<b>Tech. Information No.</b>	2043 / 2016
<b>Subject:</b>	FMC-420RW/300RW manual call point - glass panes: CAR 160327

<b>Short Description:</b>	In a small number of cases it has been identified that Manual Call Points may not be triggered as intended after the glass pane has been broken
---------------------------	---

b) Back side of the glass pane  
No date printed/engraved  
**NO NEED TO EXCHANGE**

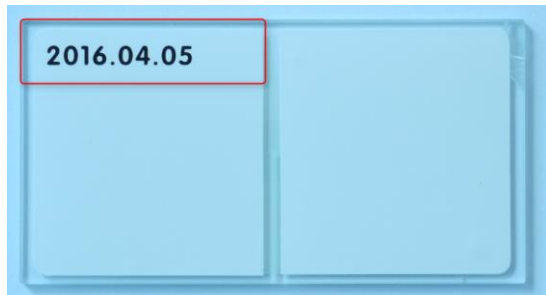
The affected glass panes can be identified by a date code engraved on the backside of the glass panes (see picture d). These glass panes might break in an unexpected way resulting in a small number of cases in not triggering or delaying alarms. The products affected are those that were delivered between January 2014 and July 2016. This fault is not found in glass panes as described in pictures b) and c).

The front side of the glass panes is the same for all versions. Differentiation is seen on the back side of the glass pane as highlighted in the following pictures.

d) Back side of the glass pane  
Engraved date  
**PLEASE EXCHANGE**

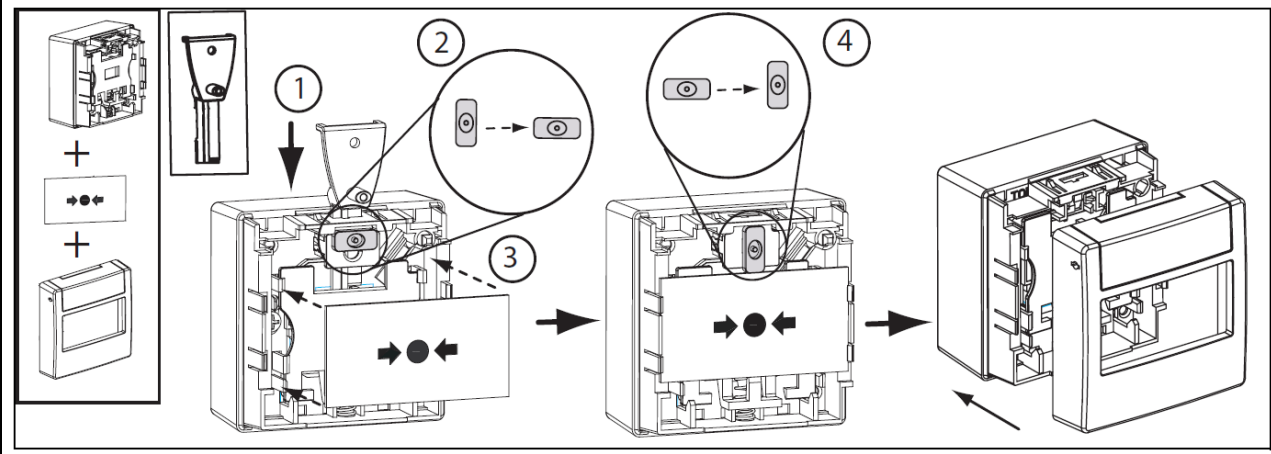
The issue is caused by a change in the design of the glass panes used in the Manual Call Point versions listed above.

- Replace affected glass panes, see *picture d)* for reference.

During the next inspection, replace all affected glass panes in all installed Manual Call Points mentioned in this document.

1. Double check during next inspection which version of the glass pane is used. You can identify 3 versions as described in *picture d)* is affected and should be replaced. (note: Versions in *pictures b)* and *c)* are not affected and do not need to be replaced)

2. Please contact the ASA RMA Desk for support, refer to this TI 2043 / 2016 form and ask for the FMC-SPGL-RW Spare glass for MCP RW, F.01U.013.504 to be sent as a replacement (see *picture c)*). Keep in mind that **1 piece (=1 box) contains 5 glasses.**  
Please don't replace the whole Manual Call Point, only the glass pane should be replaced. Please **don't send back** the replaced spare glasses to ASA. In case it is already known that an installed product is affected spare glass panes may also be ordered in advance to make the replacement process simpler.
